**ADDENDUM NO. 4  
FOR THE  
EDUCATIONAL PARK BRANCH LIBRARY**

<b>PROJECT:</b>	<b>Educational Park Branch Library</b> 1772 Educational Park Drive San José, CA 95133	<b>Addendum No:</b>	<b>4</b>
<b>OWNER:</b>	<b>City of San José</b> Department of Public Works	<b>DATE OF ISSUANCE:</b>	March 27, 2009
<b>FROM:</b>	<b>Anderson Brulé Architects</b> 325 S First Street, 4 <sup>th</sup> Floor San José, CA 95113 (408) 298-1885	<b>ARCHITECT'S PROJECT NO:</b>	<b>07-0601-0</b>
<b>TO:</b>	<b>Prospective Bidders</b>

Subject: Clarification for recommendation of proposed Cement Treated Base (CTB)  
Educational Park Branch Library  
City of San Jose, California

ATTACHMENT TO PARIKH CONSULTANTS MEMO

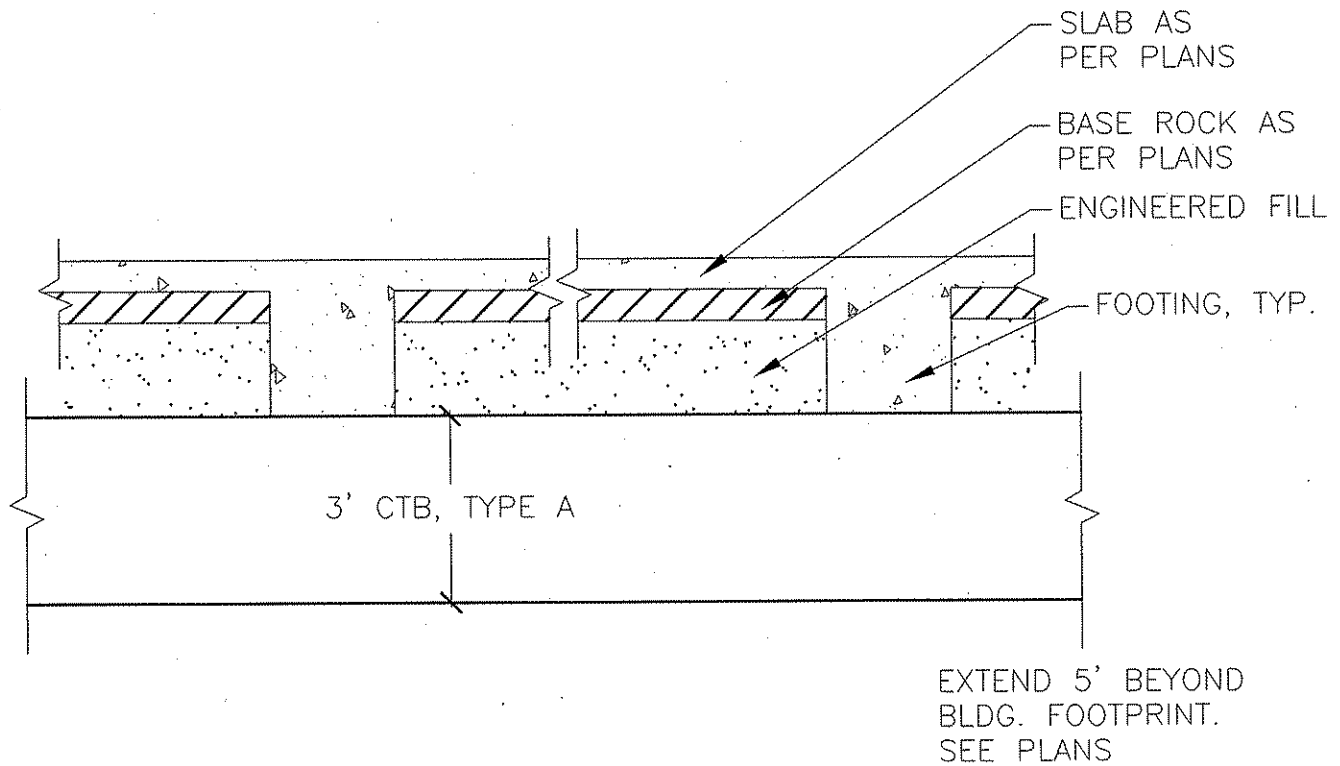
It is recommended that the proposed 3-foot thick CTB be placed under the bottom of the footings (please see attached sketch). If the CTB is not locally available, lean concrete base (LCB) can be used. The portion between the bottom of the footing and the slab/rock section can be engineered fill (does not have to be CTB or LCB). This also helps in running utilities within this fill area. Engineered fill should be non-expansive and consist of relatively granular material, free of organic and inorganic debris, having a P.I. of less than 15. Based on the soil borings, the on-site upper soils are mainly clayey materials which may not meet this criteria. Should they meet the engineered fill criteria, the upper soils may be used as engineered fill.

Based on the plans provided and our discussion with the designer, there are two 6-foot deep pier type footings (footing type 5 along grid line 9). It is our understanding that the piers will penetrate the CTB layer as the CTB layer stays at a constant depth below other footings. In our opinion, these two pier foundations can be exceptions from the CTB and no special treatment is required at the bottom of the piers.

We recommend that Type A CTB be used for the proposed project. The CTB shall conform to Caltrans Standard Specification, Section 27. The CTB shall be spread by the Type 3 spreading operation (contractor's option), and the Portland cement content of the CTB shall be 5% by weight of the dry aggregate.
